SI B71 02 18
Tools and Accessories (Engine-Chassis)

UPDATE ! VOLUNTARY EMISSIONS RECALL CAMPAIGN 18E-A02: REPLACE UNDER HOOD EMISSIONS LABEL

This Service Information bulletin replaces SI B71 02 18 **dated March 2018**

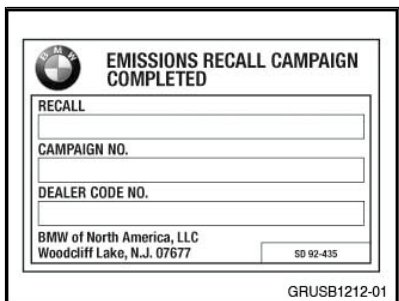
The affected vehicles were equipped with an incorrect **emissions label** which must be replaced.

An incorrect model year 2017 emissions label was installed on the model year 2018 vehicle.

1. Access engine compartment area
	2. Verify the incorrect MY 2017 emissions label is installed 3. Remove label and clean glue residue from surface area with an approved cleaner 4. Adhere correct MY 2018 emissions label
